49 CFR Part 572

[Docket No. NHTSA-00-7052]

Anthropomorphic Test Devices; 12-Month-Old Child Dummy

ACTION: Final rule.

Figure R 5
THORAX IMPACT TEST SET-UP SPECIFICATIONS

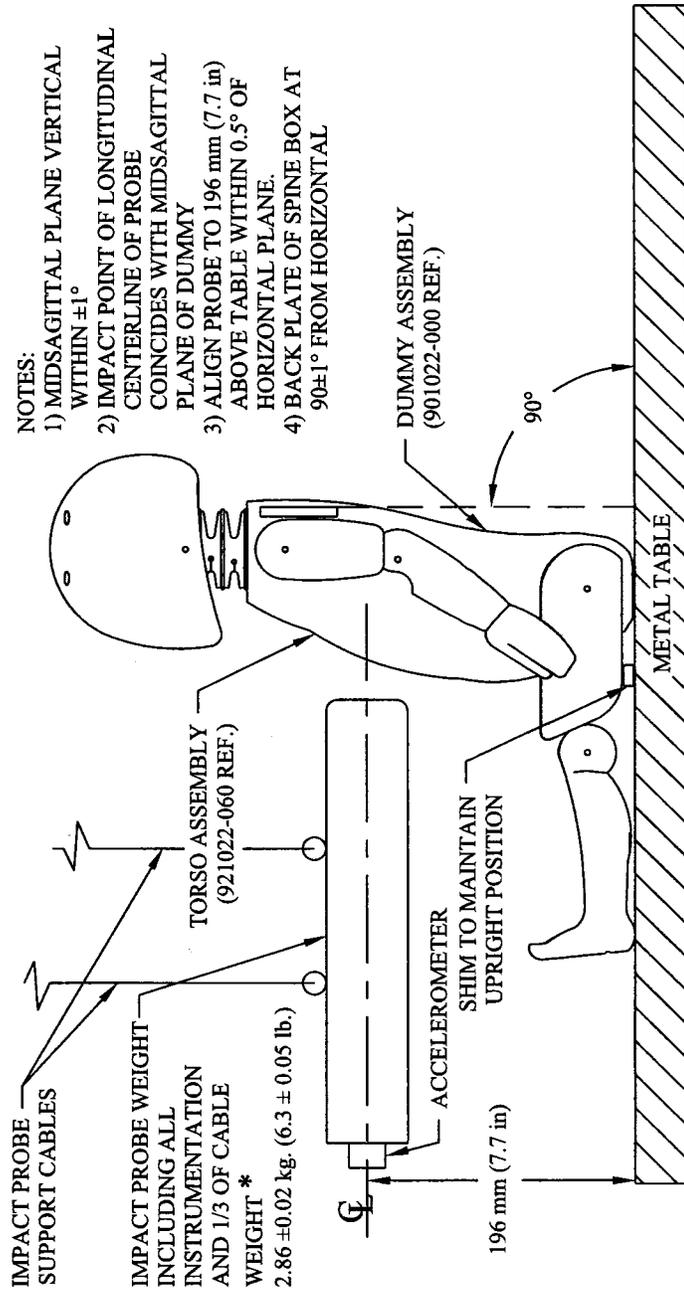
TRC suggests that the positioning of the dummy in the thorax assembly test procedure needs to be modified to match the placement shown in proposed Figure R5. The proposed regulatory text (§ 572.154(c)(3)) stated that the dummy is positioned with fingers barely touching the seating surface plane. However, Figure R5

showed the dummy’s fingers as well above the seating surface. We agree that the dummy’s arms are too short for the fingers to touch the seating surface plane and have made the necessary corrections to § 572.154(c)(3).
